SUMMARY OF: PMA # P050023/S076 AND P980023/S057

ILESTO/IFORIA DF4 ICD-CRT-Ds AND PROTEGO DF4 LEADS

Executive Summary

Figure 5. Protego DF4 Connector - Contacts and Transition Area

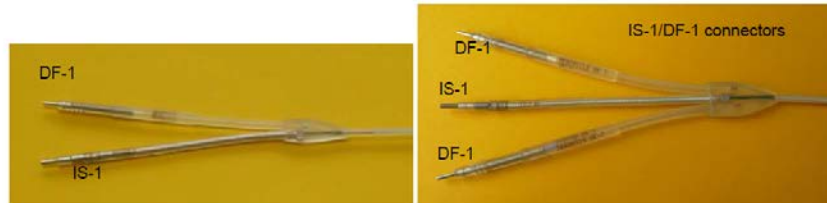
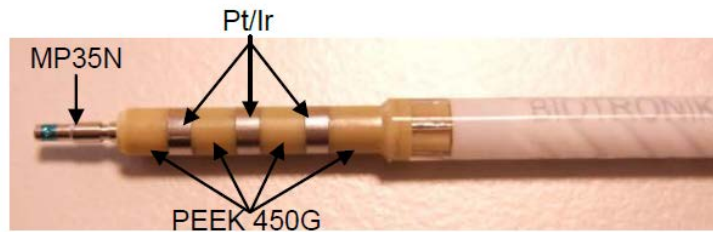
LEAD REVIEWER COMMENTS: Overall, I agree that the DF4 connector port will have limited clinical impact. As for the DF4 connector on the lead, I believe the removal of the trifurcation/bifurcation in the predecessor leads removes transition areas and potential points of failure. However, as the firm states above the over device functionality remains unchanged and from that standpoint I agree with the limited clinical impact.
